Product Bulletin

Promix LCD / SD Update for Hino FE 1426 PTO Mode 191211-1

Date:	11/12/19
Topic :	Promix LCD / SD Switching to Engage ECU PTO Mode on HINO FE 1426
Software Ver:	Promix LCD – Main 3.0 (For LCD Ver 01 PCB – Main 8.4); Promix SD 1.7

(Photo – Using the Promix Universal Main Vehicle Harness White Connectors)

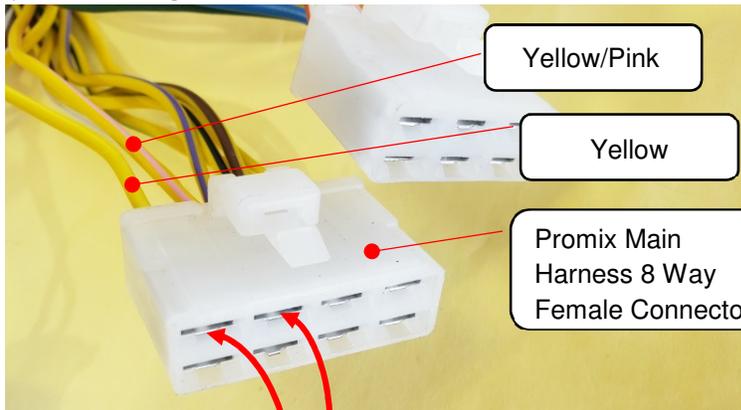
Promix LCD and SD now have the capability to automatically engage ECU PTO mode on Hino FE 1426. In PTO mode the vehicle ECU will maintain engine RPM regardless of engine load.

Yellow/Pink – Connect to fused +24v supply

Yellow – Switched +24v to Red/Black wire of vehicle PTO connector

Relay contacts within the Promix console join the Yellow/Pink and Yellow wires when analog revs control is selected and appropriate lockouts are active. Maximum load for this circuit must be below 60w.
